# SUSITNA HYDROELECTRIC PROJECT

ACRES SPECIALIST CONSULTANTS PANEL

REPORT ON SPECIALIST CONSULTANT  
PANEL MEETING NO. 4  
NOVEMBER 18, 1981

SPECIALISTS CONSULTANTS PANEL MEETING NO. 4  
BUFFALO, NEW YORK - NOVEMBER 18, 1981

SCALE: 0 20 40 FEET

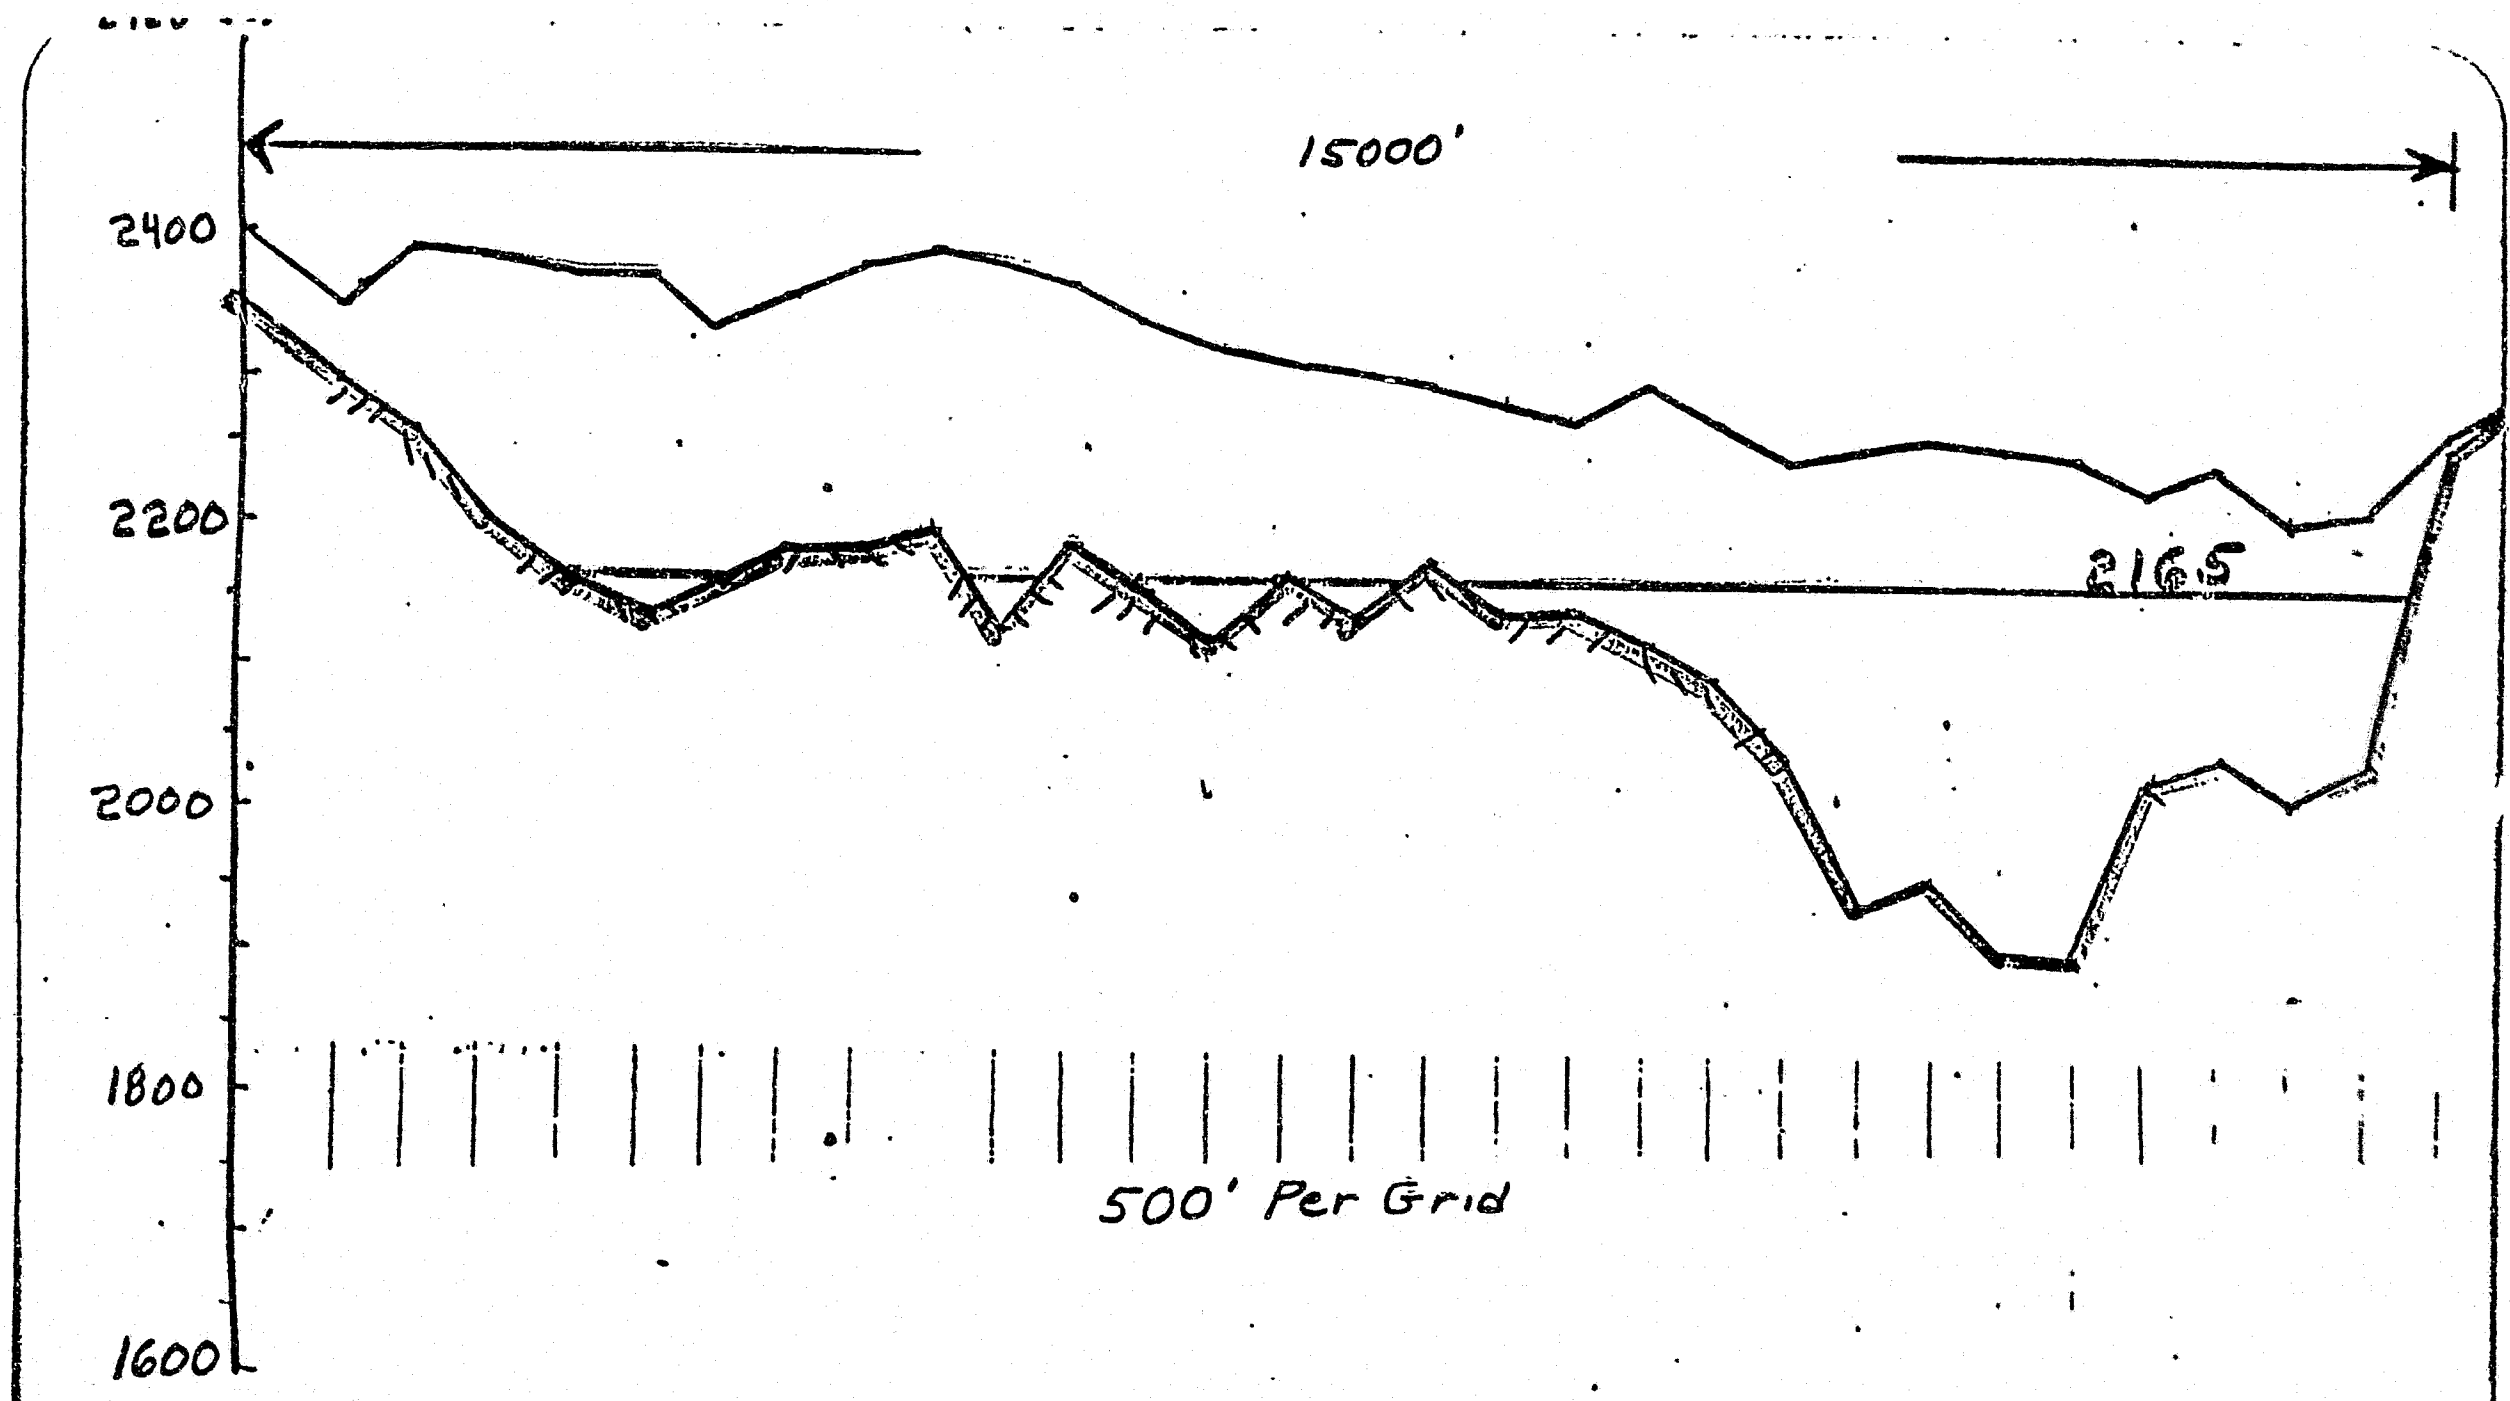
Dr. Hendron could not see liquefaction being a problem except in isolated zones which might lead to settlement of the saddle dam. J. Lawrence stressed that only 15 feet of water were retained by the dam, and suggested that an allowance for settlement could be built into the dam.

Dr. Hendron said that the liquefaction will not be regular and therefore the settlement will lead to cracking. Acres said that only an 1,100-foot length of the saddle dam is normally wetted.

Dr. Peck was not happy about the Watana saddle dam, even 10 feet high, and did not think that the slurry wall and grouted cutoff of the relict channel could be justified. He thought that the height of the main dam should be fixed on overall economic grounds.

The panel recommended that the reservoir level be adjusted to eliminate the need for a saddle dam. The PMF water level would then be fixed by the lowest ground level in the relict channel area with suitable freeboard allowance.

ACCELERATION VS DEPTH AT CENTER OF DAM

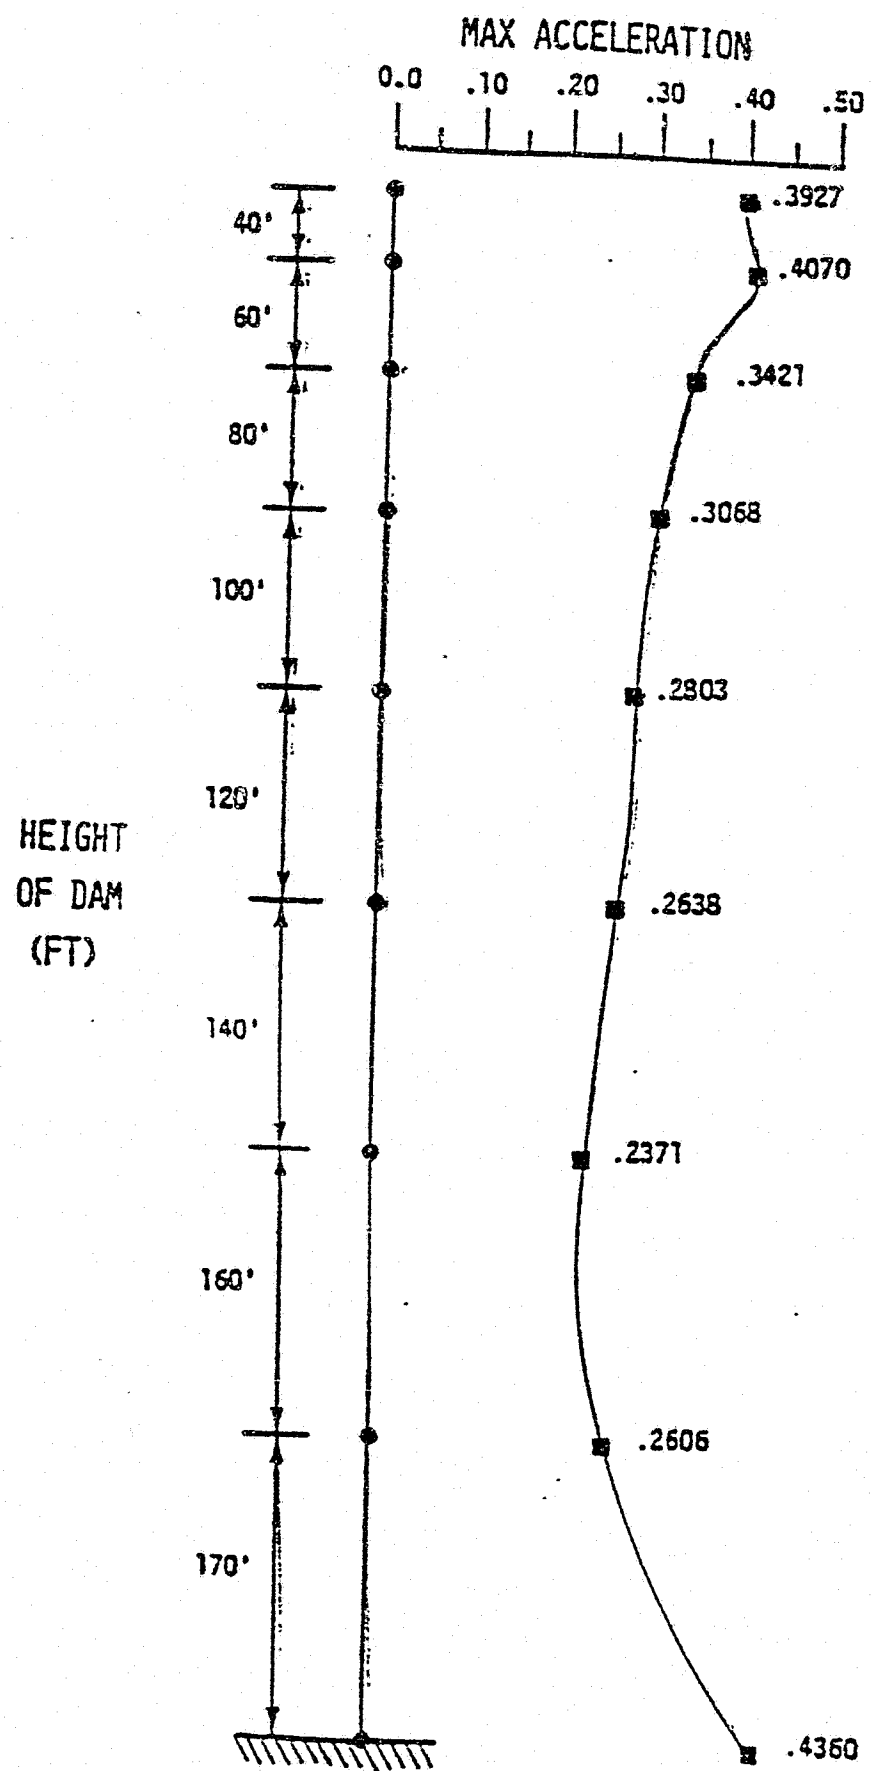
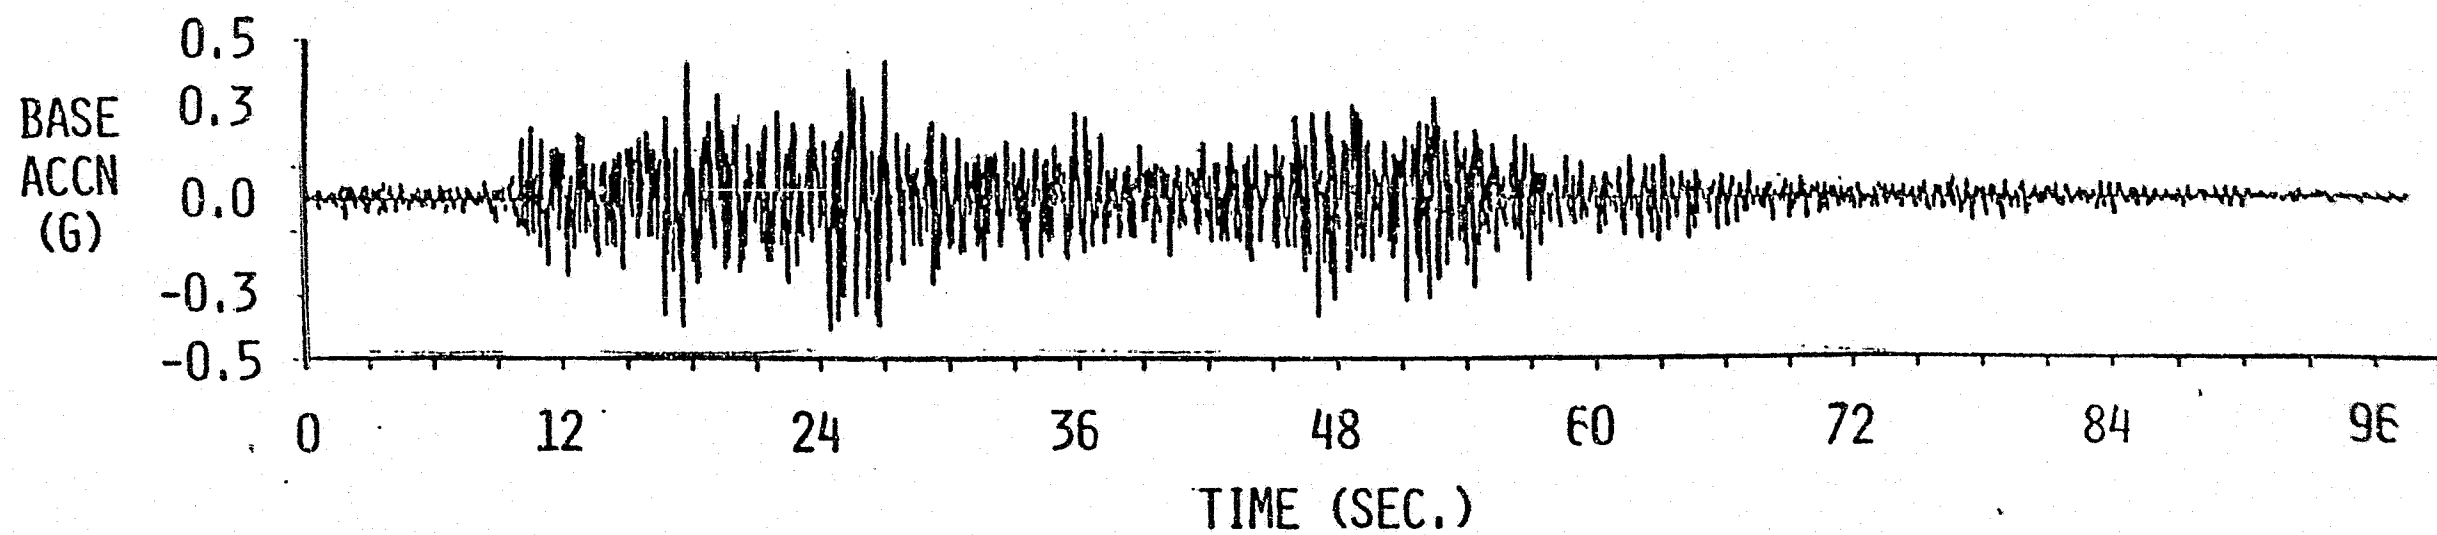
A brief description of the dynamic analysis of the dam section was presented. Lamb stated that at the previous panel meeting Dr. Seed was not happy about the size of the finite element mesh used for the analysis. Acres was intending to rerun the analysis using a smaller mesh.

The properties used were discussed and Dr. Peck stressed that whenever possible a range of properties should be used in analysis. Both Dr. Peck and Dr. Hendron agreed that finding background information on this type of material was very difficult.

The material properties used in the dynamic analysis, the earthquake 25 cycle history, accelerations and shear stresses in the dam were displayed.

The panel generally concluded that there was a need to firm up on material properties and geometry and then do further dynamic analysis.

CREST DETAIL

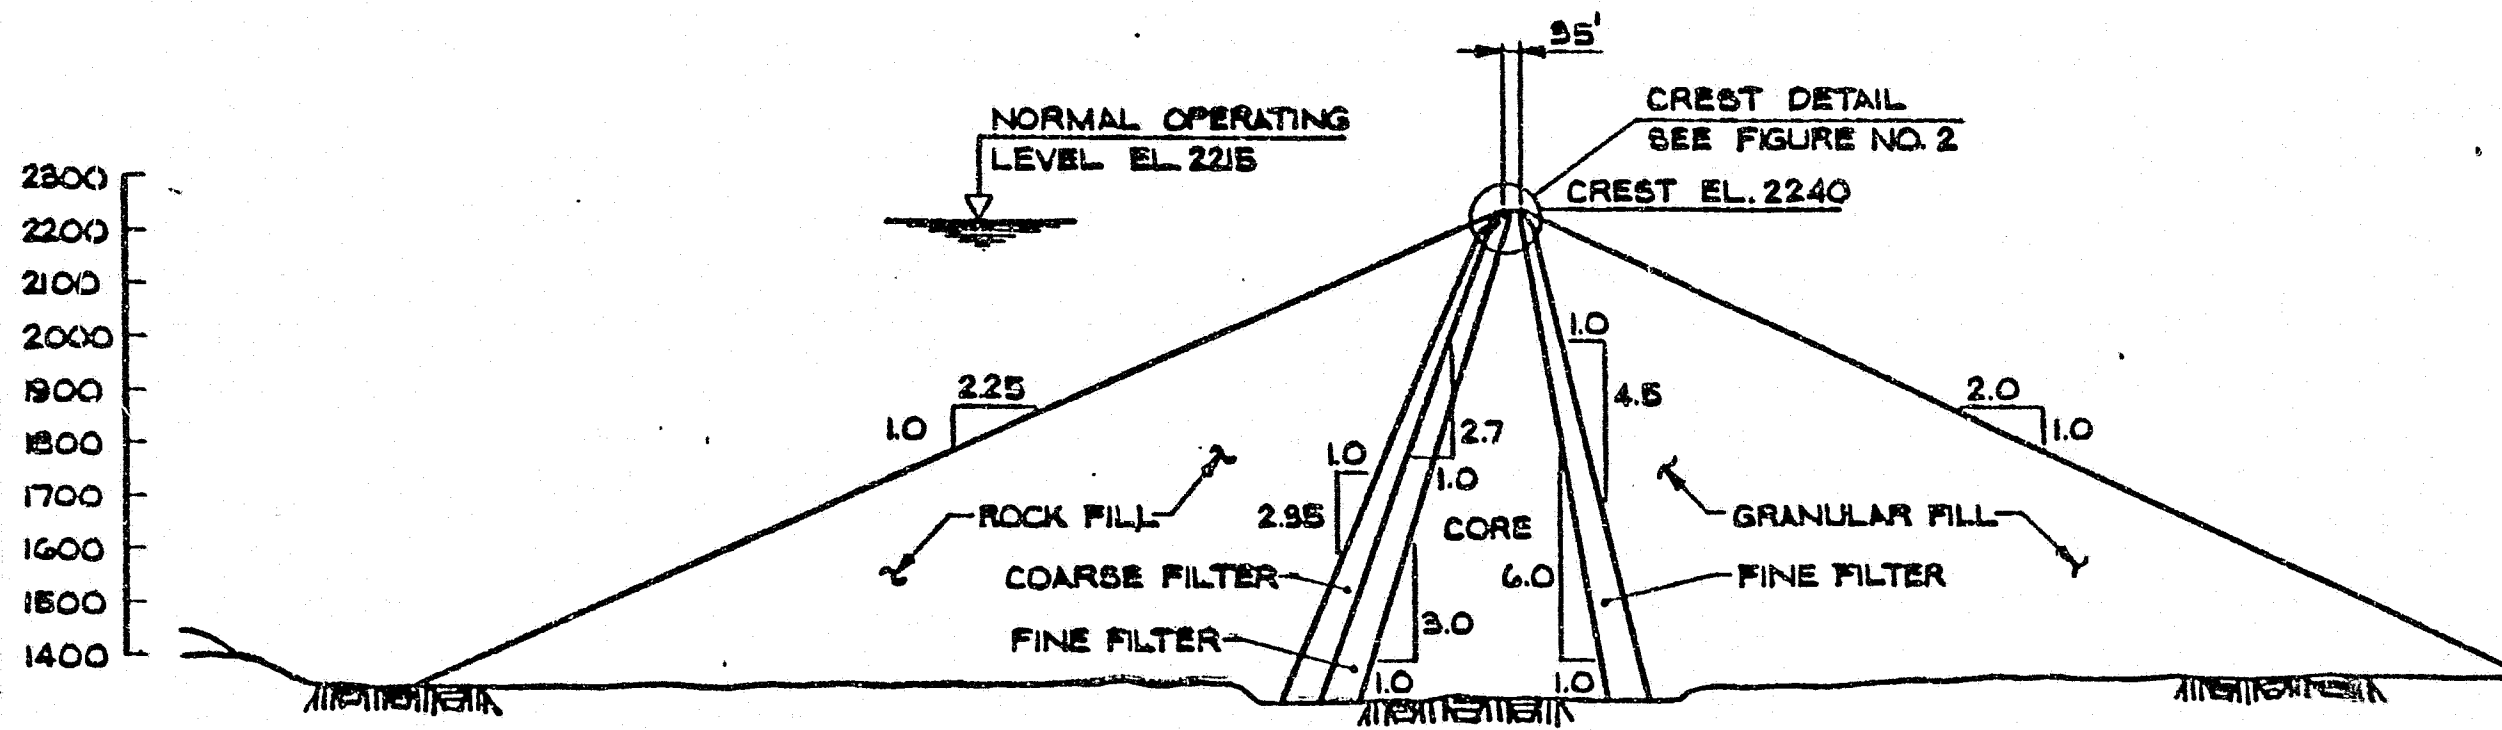
The detail at the dam crest was presented and discussed. Dr. Peck said that even if a crack opened up 6 inches wide the whole length of the dam, this would not be a major problem. Lamb said that post-construction settlement of 1 percent for static and 0.5 percent (5 feet) for earthquake conditions, had been allowed. Dr. Peck thought that 1 percent was probably too much for the gravel fill downstream and not enough for the rockfill upstream.

It was noted that it had been suggested that the settlement of rock fill would be very small, in the order of 0.1 percent. Dr. Peck did not think that this was an appropriate figure to use.

Dr. Hendron suggested that a 25-foot to 50-foot wide zone be constructed next to the coarse filter in layers with half the normal thickness to provide a well compacted transition zone.
